**292 72 2023**

**ARRIEL 2 B - B1 - C - C-PM - C1 - C2 - C2-CG - S1**

**Subject: Module M04 (power turbine). Solid power turbine disk shaft.  
Application of modification TU 23.**

**Ensemble turbine libre**  
Power turbine assembly

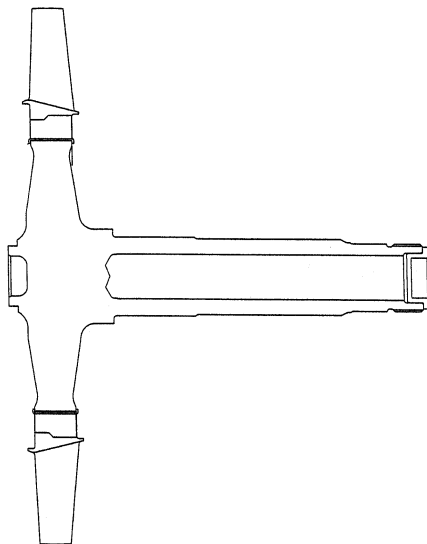
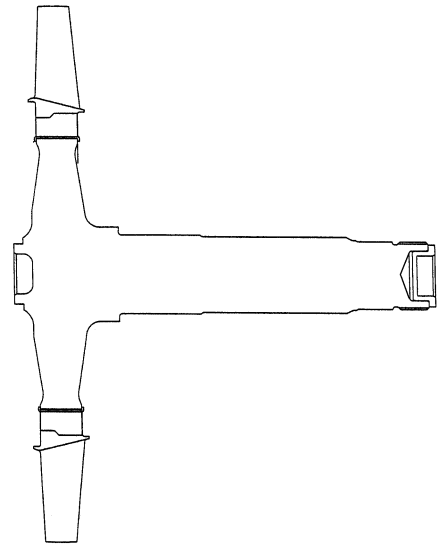
This modification consists of eliminating the 20 mm diameter x 138 mm length hole drilled into the shaft of the power turbine disk.
